CALIFORNIA COASTAL COMMISSION

**F 8d****STAFF RECOMMENDATION****ON CONSISTENCY DETERMINATION**

Consistency Determination No.	CD-089-06
Staff:	MPD-SF
File Date:	11/09/06
60th Day:	1/8/07
75th Day:	1/23/07
Commission Meeting:	12/15/06

Installation of a 44 ft. telemetry antenna enclosed by a 62 ft. diameter radome (and related utilities and interior building repairs) (Exhibits 3-5)

EXHIBIT NO. 9
APPLICATION NO.
CD-89-06

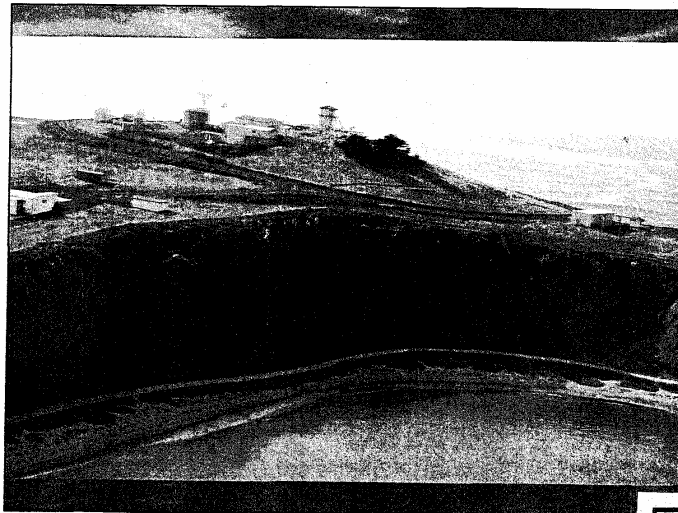
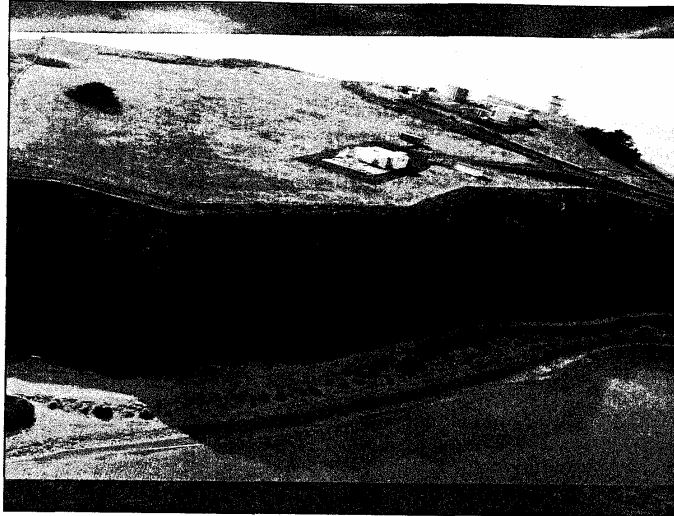
The Commission believes the appropriate mitigation would be landscaping and painting to screen buildings where feasible, and notes that the Air Force is considering these. However, absent a definitive commitment and specific painting and landscaping plans, the Commission is unable to find that the Air Force has minimized the project's visual impacts or that the project as proposed would be consistent with the public view protection policy (Section 30251) of the Coastal Act. The Commission is therefore conditioning its concurrence to require the Air Force to commit to a process and timetable for providing specific painting and landscaping plans, which would be subject to Commission review and concurrence (pursuant to the "phased review procedures – see page 7), to assure that appropriate colors are used, appropriate vegetation (e.g., non-invasive, drought resistant, native plants from local stock) will be planted and maintained for the life of the facility, with particular emphasis on the radome structure and those buildings most highly visible within views from public areas to the north, northeast, and east of the Pillar Point Station (in particular the prominent buildings shown in Exhibit 9). Only as conditioned can the Commission find the project consistent with Section 30251.

1. Submittal and Implementation of Landscaping Plans. Within three months from the date of Commission action, the Air Force will submit specific painting and landscaping plans, which would be subject to Commission review and concurrence, sufficient to assure that appropriate colors will be used (for painted buildings), and that appropriate vegetation (e.g., non-invasive, drought resistant, native plants from local stock) will be planted, and maintained for the life of the facility, with particular emphasis on screening the radome sub-structure and those buildings most highly visible within views from public areas to the north and east of the Pillar Point Station (see Exhibits 5, 7 and 9 depicting the most prominent buildings). Implementation of the visual improvements shall commence no later than one year from the date of Commission action.
